P-8690-1

27810

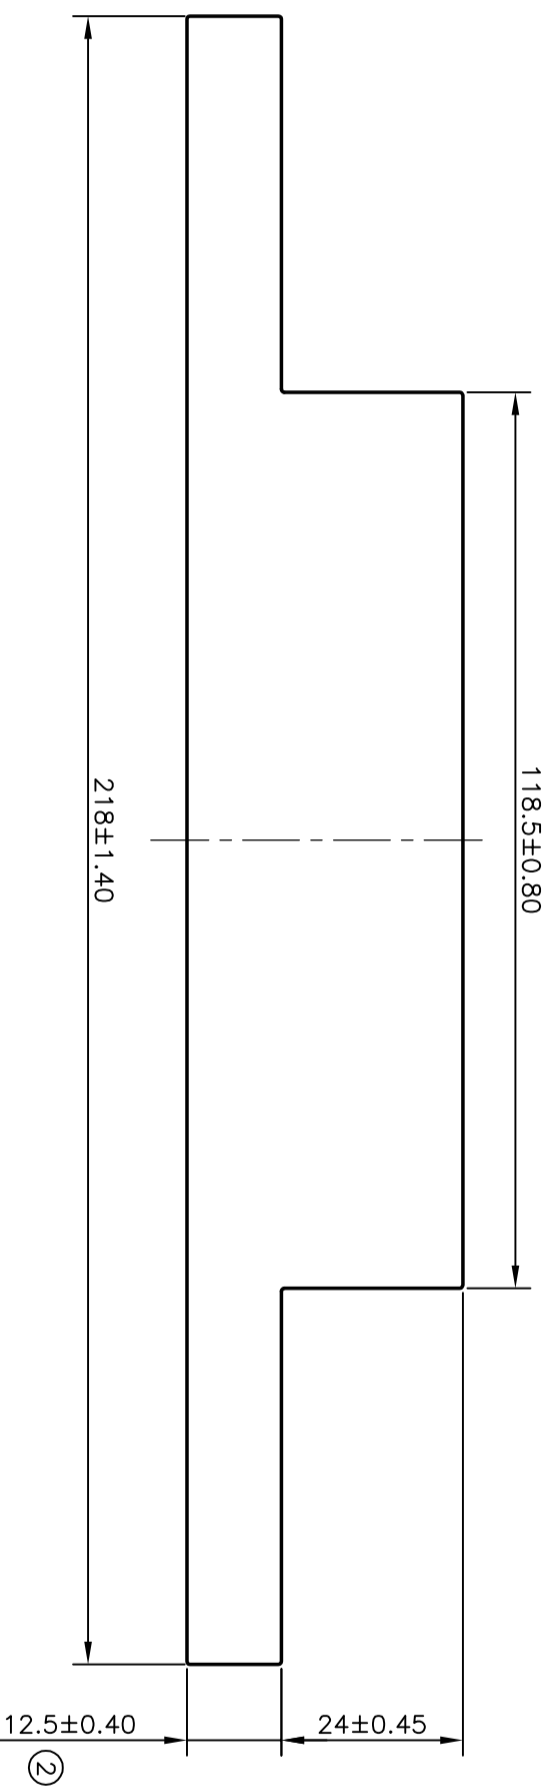
ISSUE-2 DIMENSION CHANGED FROM  
 $12.00 \pm 0.40$  TO  $12.50 \pm 0.40$  &  
 WEIGHT ALSO CHANGED FROM  
 $14.742$  kg/M TO  $15.036$  kg/M
